# **Wellington City Proposed District Plan**

## **Stream 2 – Part 3, Residential Zones – Part 5: Large Lot Residential Zone**

### **Section 42A of the Resource Management Act**

## Part 5: Large Lot Residential Zone

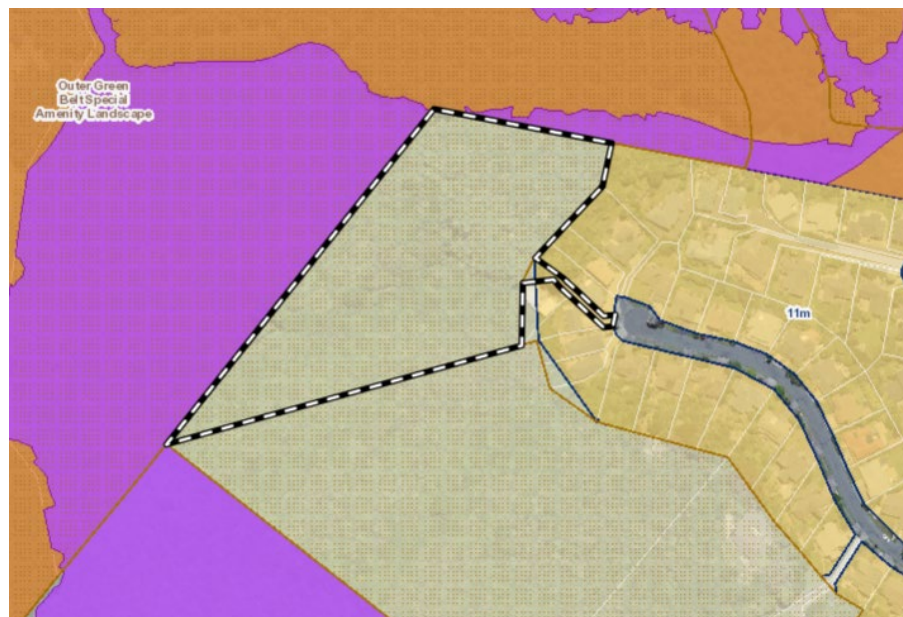
18. In response to Peter Charlesworth’s submission [248.3], the site at 11B Wilmshurst Place is large and has a split zoning under the ODP, with a large portion of the site zoned Outer Residential Area and the remainder zoned Rural Area. This is shown below.

19. As such, the submitter argues that the proposed LLRZ imposes development constraints on the Outer Residential portion of the site that do not currently exist, and that this zoning would be contrary to the NPS-UD. The site is in an area characterised by low density residential development to the north and larger properties in a semi-rural setting to the south. The site itself contains one large residential building, consistent with the Large Lot Residential zoning. However, acknowledging that the PDP zoning would reduce existing development capacity and that the site is on the periphery of the Outer Residential Area, I recommend that the zoning of 11B Wilmshurst Place is changed to MRZ. Alternatively, the zoning could be split across the site, with the split following the existing zoning, ie the area comprising the existing Outer Residential Area land zoned MRZ and the remainder LLRZ.

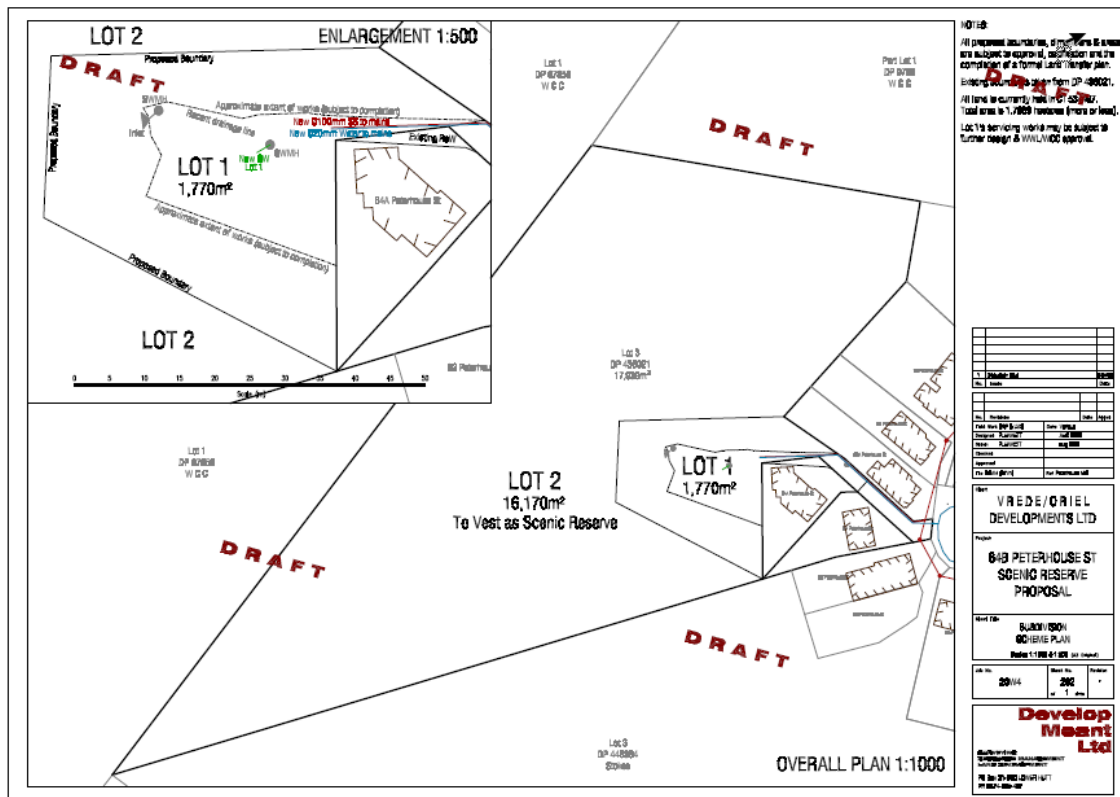
22. The submitter has requested redrawing the boundary between the MRZ and LLRZ portions of this site to reflect an approved subdivision consent. The plan below shows the location of the

subdivision boundary. Lot 1 will contain a residential unit, whereas the balance lot (Lot 2) is to be vested as a scenic reserve. Hence the request is to extend the MRZ to incorporate the new residential lot.

23. Due to the size of Lot 1, it could accommodate a MDRS development of up to three household units. The site is located at the end of a residential street and essentially extends the residential development one site further to the west. Rezoning this land MRZ would not detract from the established character and is in line with the expectations of the NPS-UD. As such, and given the remainder of the site (Lot 2) will remain in an undeveloped state, I accept that it would be appropriate for the site at 64B Peterhouse Street to be rezoned to MRZ.
24. In response to Karepa Dell's submission [241.1], I note that the site is large and zoned Rural Area under the ODP. As shown below, the site is located immediately to the north of the site at 110 Mitchell Street and has the same characteristics, including the established native vegetation, stream and hazard profile.
